Access Report

Seniors Community
Lot 3 Lakewood Drive
MERIMBULA NSW

For: Justice Fox
Ref: 22113

Development application documentation for the proposed Seniors Community located at Lot 3 Lakewood Drive Merimbula, has been reviewed against current and applicable accessibility legislation.

Figure 2 | Typical Independent Living Unit Arrangement

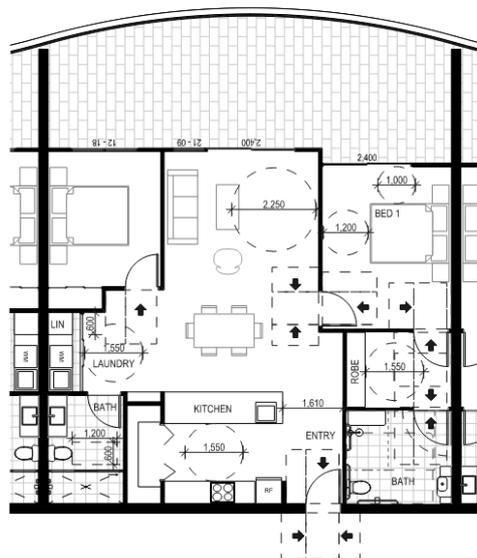
Adequate circulation areas provided at building entrances and at the entrance to individual units. A door leaf size of 920mm should be used as a minimum which will achieve the required clear width of 850mm.

All corridors within the dwellings meet the required width of 1000mm minimum.

The main bedroom within each dwelling offers adequate circulation area. Additional requirements listed above to be implemented during detailed design.

The ensuite (main bathroom) to Bedroom 1 within each of the units is conducive to the requirements of an accessible bathroom, meeting the requirements of the SEPP.

The toilet within the ensuite of each unit meets the requirements of AS4299.

The open plan arrangement of living / dining areas within each of the units provides sufficient area to satisfy SEPP requirements for circulation spaces within living and dining rooms.

Kitchens within each unit have adequate width to accommodate 1550 mm clear between opposing benches.

Laundries are provided with adequate circulation areas being in a cupboard configuration.

A linen cupboard, 600mm wide, is provided within the laundry of each unit. The requirement for adjustable shelving should be addressed during detailed design.

Figure 2 | Overall Site Plan (in part)

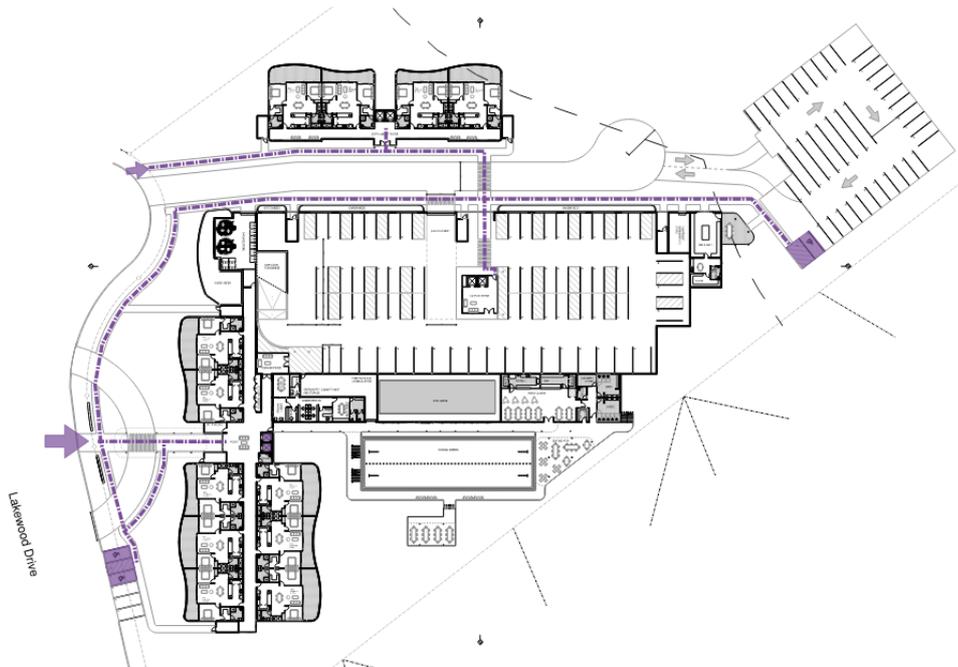
An accessible path of travel is provided to the building entrances from the allotment boundary along Lakewood Drive via formed pathways that are level.

An accessible path of travel is provided from accessible carparking areas via formed pathways that are level.

An accessible path of travel is provided between the two buildings on the site via formed pathways that are level.
